# HISTORIC AND DESIGN REVIEW COMMISSION

June 16, 2021

**HDRC CASE NO:** 2021-100  
**ADDRESS:** 415 MISSION ST  
**LEGAL DESCRIPTION:** NCB 946 BLK 2 LOT 22  
**ZONING:** RM-4,H  
**CITY COUNCIL DIST.:** 1  
**DISTRICT:** King William Historic District  
**APPLICANT:** Jake Jazdzewski/JAZDZEWSKI JAKE & MONICA  
**OWNER:** Jake Jazdzewski/JAZDZEWSKI JAKE & MONICA  
**TYPE OF WORK:** Relocation of garage structure, modifications  
**APPLICATION RECEIVED:** May 18, 2021  
**60-DAY REVIEW:** Not applicable due to City Council Emergency Orders  
**CASE MANAGER:** Stephanie Phillips  
**REQUEST:**

# JAZDZEWSKI RESIDENCE RESIDENTIAL REMODEL

**2 SITE PLAN - NEW IMPROVEMENTS**  
SCALE: 1" = 20'-0"

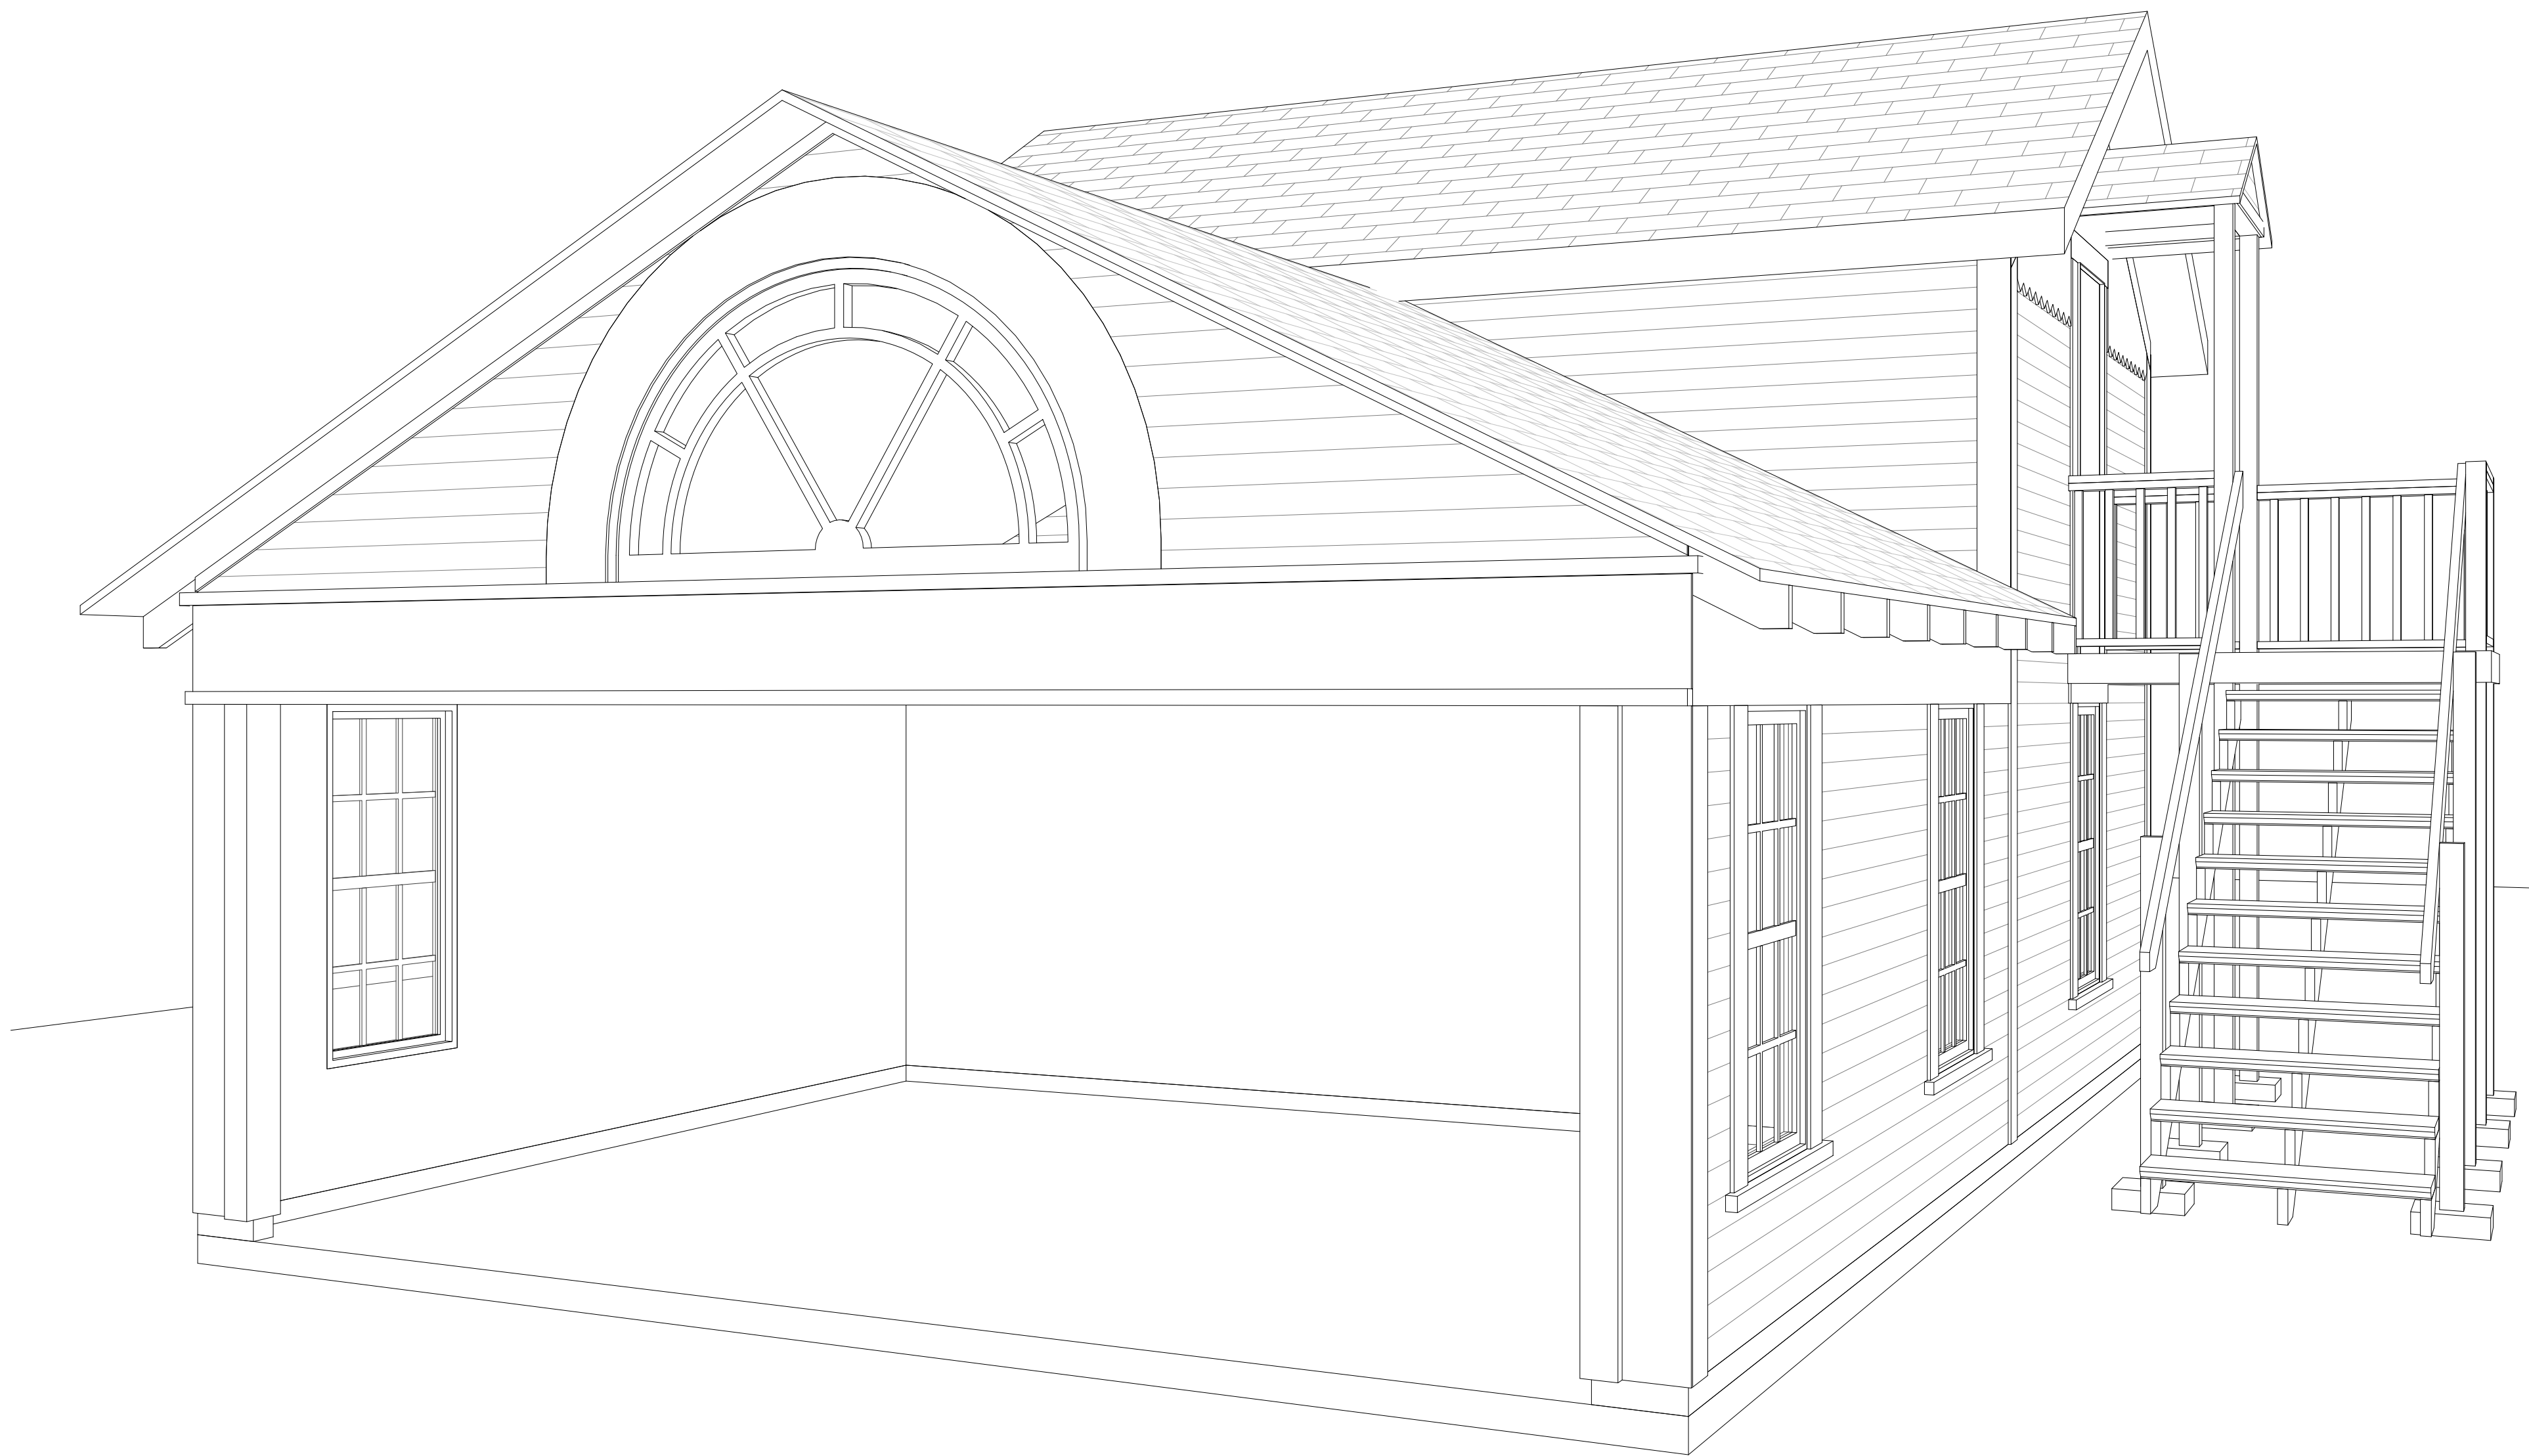
- c. RELOCATION – The applicant has proposed to relocate the existing rear accessory structure approximately 6 feet to the southeast to accommodate a new backyard configuration, to include an inground pool that is eligible for administrative approval. Staff generally finds the request to be appropriate due to its limited distance and retention of the historic development pattern of rear structures in the district. The new side setback is not indicated in the plans. The applicant may be required to obtain a setback variance from the Board of Adjustment.

- iv. That the applicant submits a detailed plan for structure relocation, to include stabilization measures and foundation details for the structure's new location, prior to the issuance of a Certificate of Appropriateness.
